SLR Project No.: 184395

RE: 250733/FUL – Highways Update

DUCKS NEST FARM, ARBORFIELD

GENERAL ARRANGEMENT –
POTENTIAL CYCLE ROUTE (SANDY
LANE TO DOLES LANE)

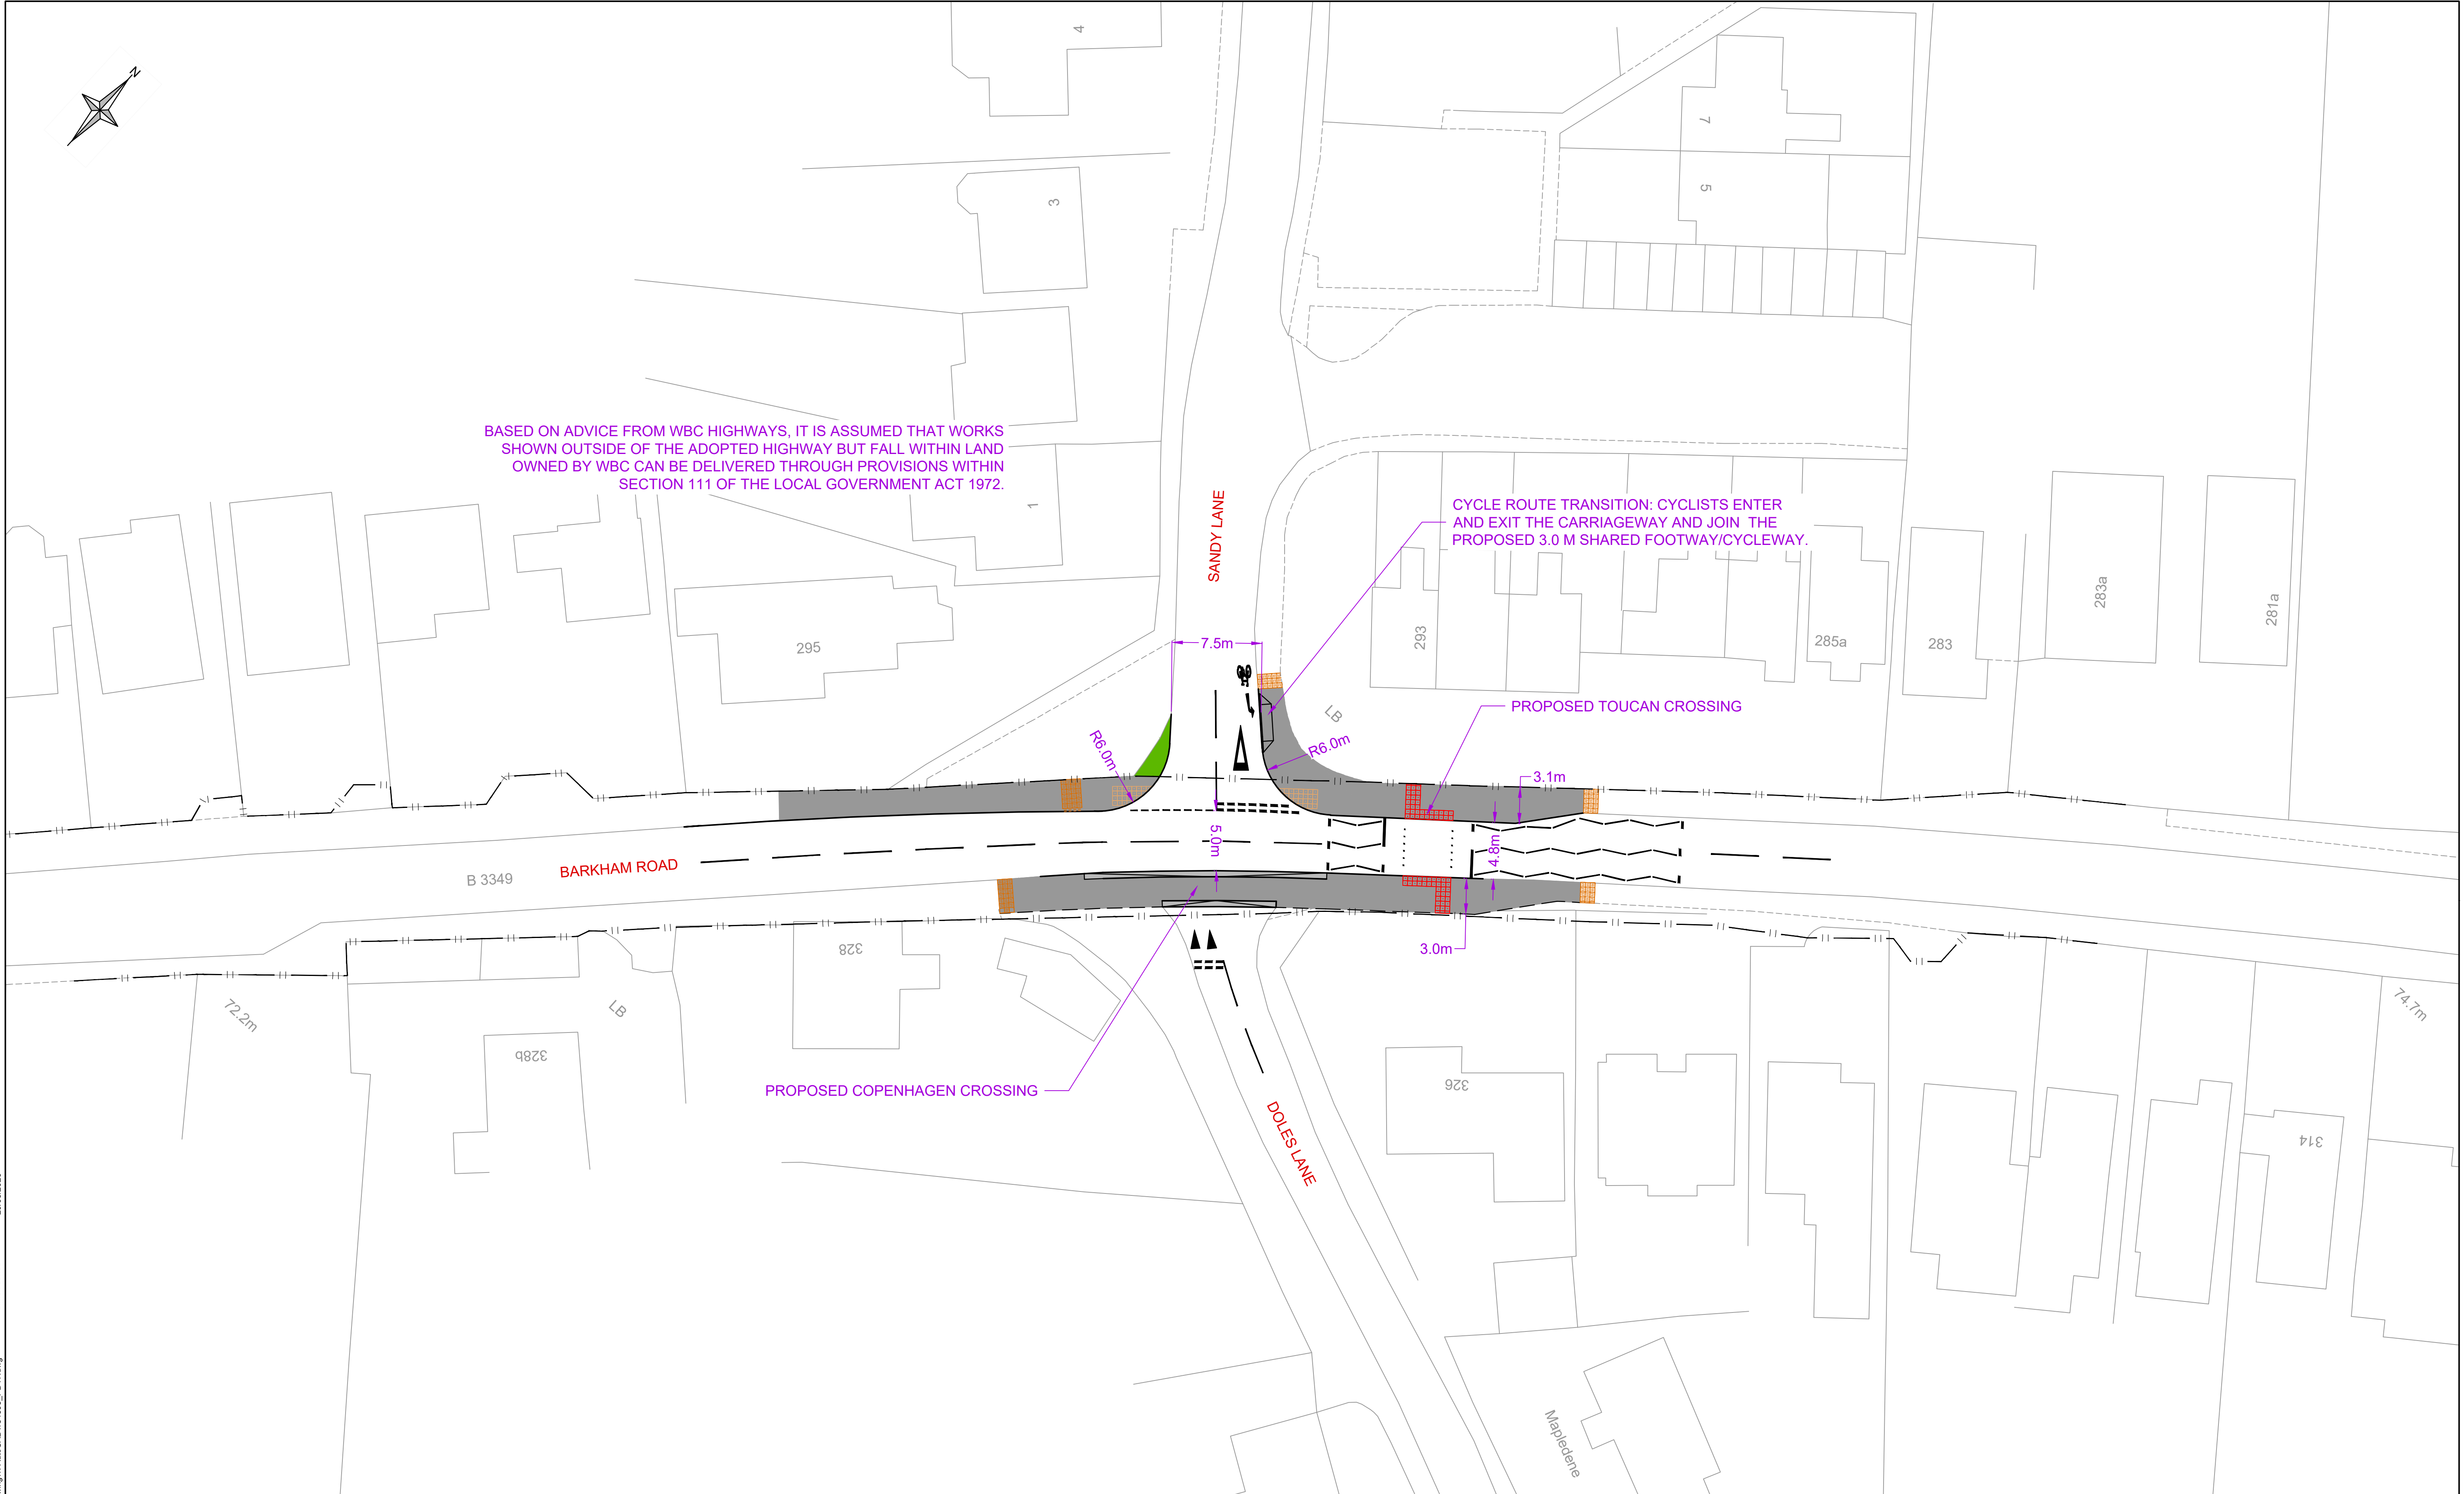
Finally, it was requested that the Applicant identify a scheme that would improve the ability of active mode users to cross Barkham Road at the Sandy Lane/Doles Lane crossroads. Whilst relatively remote from the application site, it is understood that the justification for an enhanced crossing would offset the modest increase in traffic from the proposed development along the Barkham Road corridor. As noted in the Transport Assessment, this is expected to be in the order of just ten vehicles in the morning and evening peak travel periods.

However, as you will aware, there are sections of Sandy Lane and Doles Lane that sit outside of the adopted highway. To this end, and whilst it would suggest that at least some of this land is owned by WBC, my client is understandably concerned that linking an improvement scheme at this location to its application opens them up to a potential ransom situation.

To overcome this issue my client considers the most appropriate why for a crossing point to be secured in this location would be for an either/or mechanism being included in the s106 Agreement. This being, the Applicant delivering the scheme shown on Drawing 184395-PD17 Rev A providing that WBC first dedicates and adopts the WBC owned land required to implement the proposal as highway at nil cost to my client or if the land has not been adopted as highway by a certain date providing a defined financial contribution for WBC to deliver the crossing.

Note added: works shown outside of the adopted highway but falling within land owned by WBC.

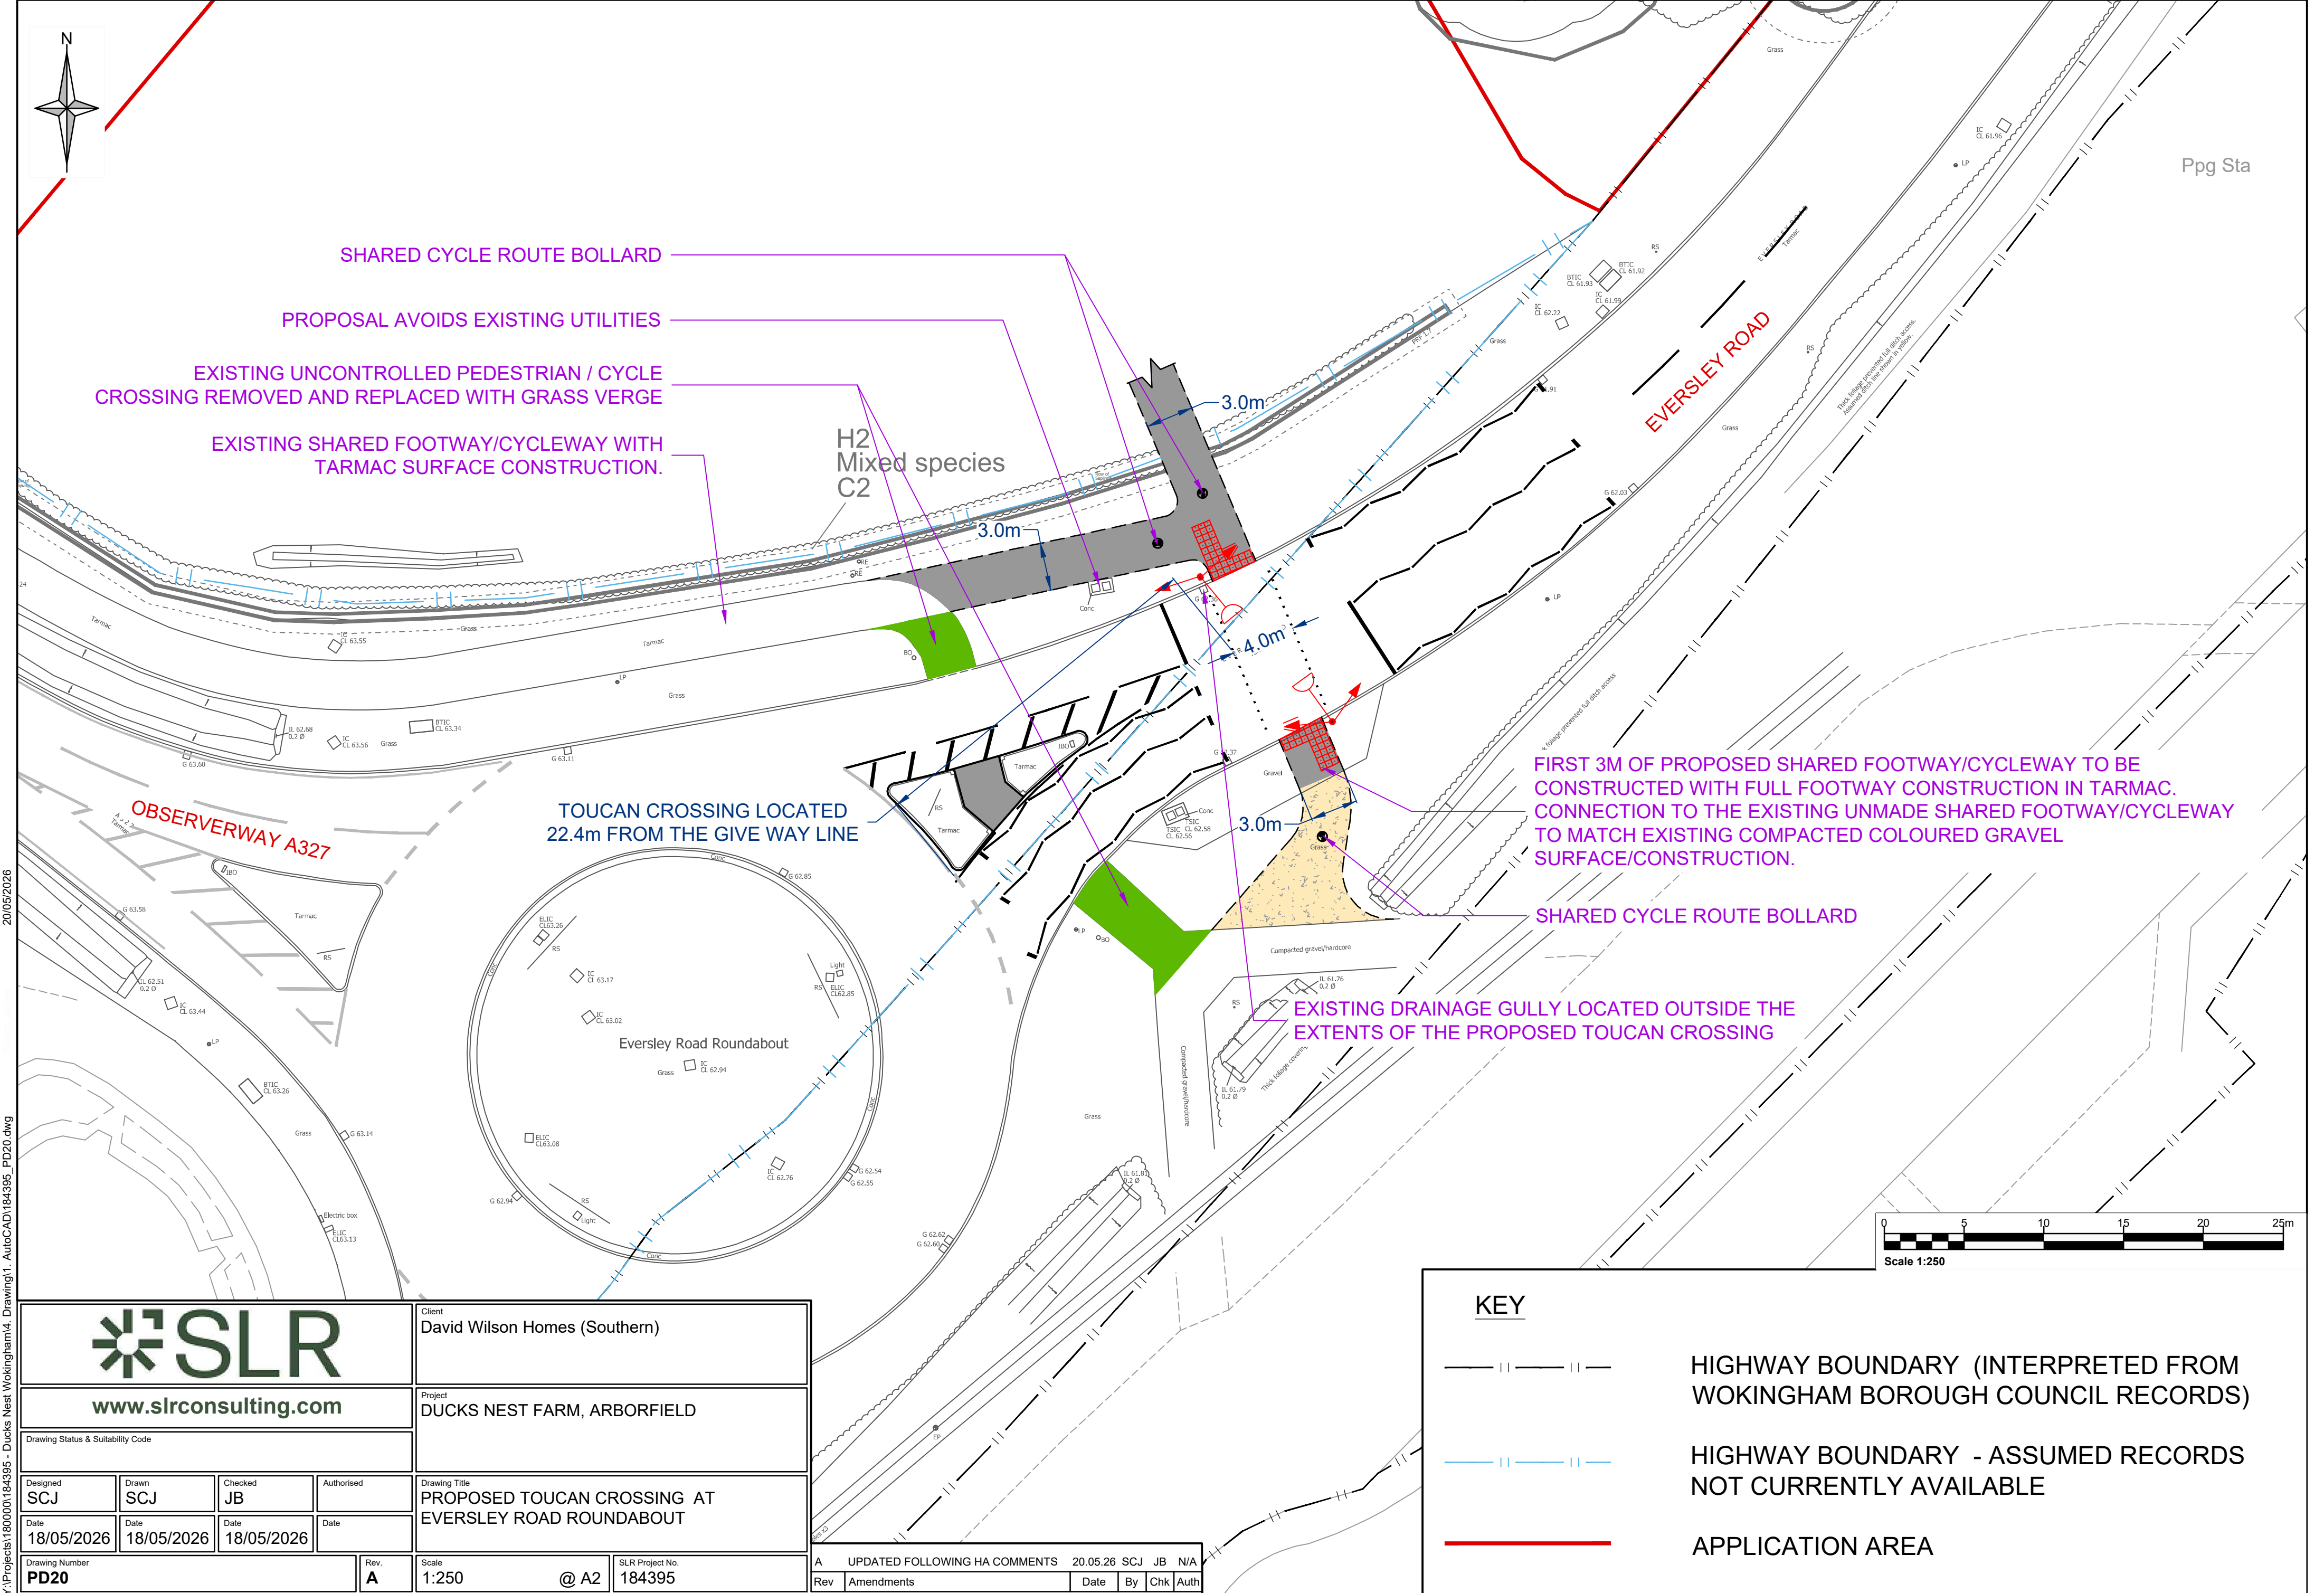
- Drawing 184395-PD20 Rev A – the replacement of the existing uncontrolled crossing that provides a link between Observer Way and Baird Close, with a toucan crossing.
- Drawing 184395-PD19.1 Rev A – the relocation of the proposed parallel crossing that would link the site with Langley Common Road to a point 20 metres back from Eversley Road/Langley Common Road, and its conversion to a toucan crossing. Alongside this a shared footway/cycle path is provided through to Rickman Close and then to the crossing that will be provided on Langley Common Road by Crest Nicholson.
- Drawing 184395-PD18.1 Rev A – as with the above, but with the shared footway/cycle path shown parallel to Eversley Road before proceeding to the crossing that will be provided on Langley Common Road by Crest Nicholson.
- Drawing 184395-PD17 Rev A – an indicative active mode crossing at the Sandy Lane/Doles Lane crossroads

- To provide an enhanced crossing that would link Observer Way with Baird Close, as shown on Drawing 184395-PD20 Rev A.
- To amend how future residents would cross Eversley Road in order to access Langley Common Road, as is shown on Drawings Drawing 184395-PD18.1 Rev A and Drawing 184395-PD19.1 Rev A.
- To provide a scheme that would encourage the use of cycles to/from the proposed SANG via Link Road and Harts Close as shown on Drawing 184395-PD16 Rev A.
- To *either* deliver or provide a financial contribution towards a new active mode crossing at the Sandy Lane/Doles Lane crossroads, as indicatively shown on Drawing 184395-PD17 Rev A.
